<b>ADDENDUM TO THE IFQ DOCUMENTS</b>	<b>Page Number</b> 1	<b>No. of Pages</b> 2
<b>Addendum No. One</b>	<b>Date Addendum Issued:</b> April 23, 2018	
<b>Issuing Office</b> Department of Natural Resources, Procurement 550 West 7 <sup>th</sup> Ave., Suite 1330, Anchorage, Alaska 99501 Phone: 269-8666 Fax: 269-8909	<b>Previous Addenda Issued</b>  None	
<b>Project:</b> Fahrenkamp Parking Lot <b>Project No.:</b> ASP 10-18-922 – Re-solicit	<b>Date and Hour of Quotes Due</b> April 30, 2018, 2:00 pm

### **Questions / Answers:**

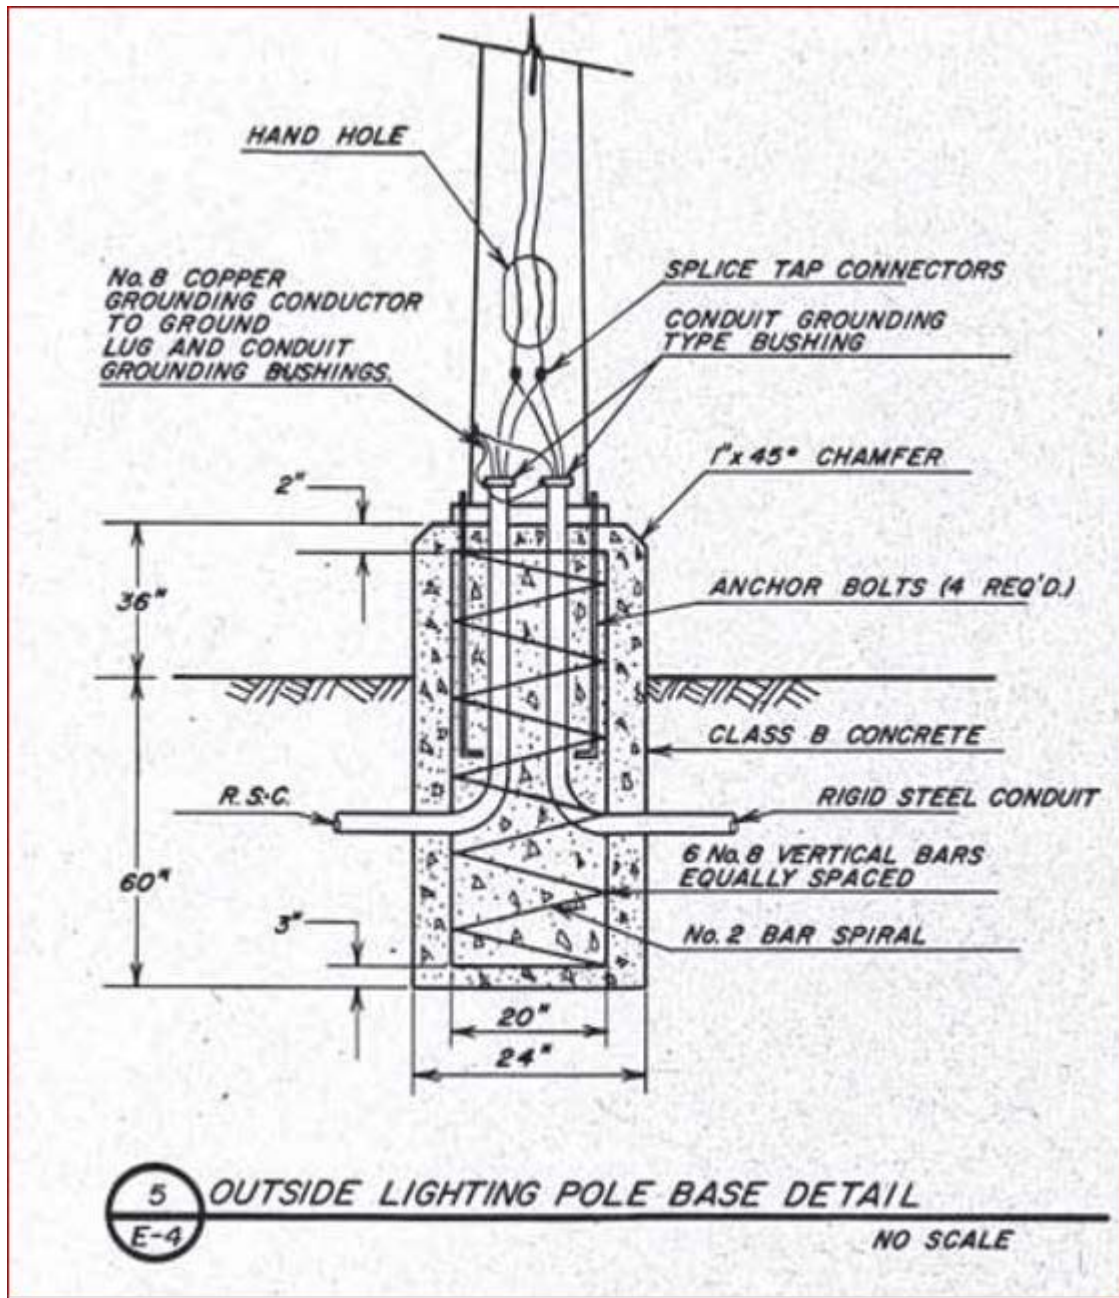
- a. Using 1-1/4-inch conduit for the headbolt heater circuits is acceptable. Using 1-inch conduit for the lighting circuits is acceptable.
2. Drawing E1 detail 1 & 2 show a 7" diameter by 18-foot steel piling with a 18" diameter by 40" high concrete barrier for the parking lot lighting. This is not a typical installation for site/parking lot lighting. Typical installations for parking lot lighting/site lighting utilize a 24" sonotube filled with 4000psi concrete at a depth below finish grade of 6 feet with between 2 & 3 feet above finish grade. Please confirm this is a acceptable installation.?

- a. No exception taken to matching existing design. Note 36-inch height above final grade with 1-inch 45 degree chamfer, 24-inch diameter, to 60 inches below grade, and reinforcement as shown below (detail from 1986 Denardo Center record drawing). Provide adjustment nuts on the anchor bolts to be able to align the pole and base cover to match the pole finish. (Excerpt on page 2 of this addendum)
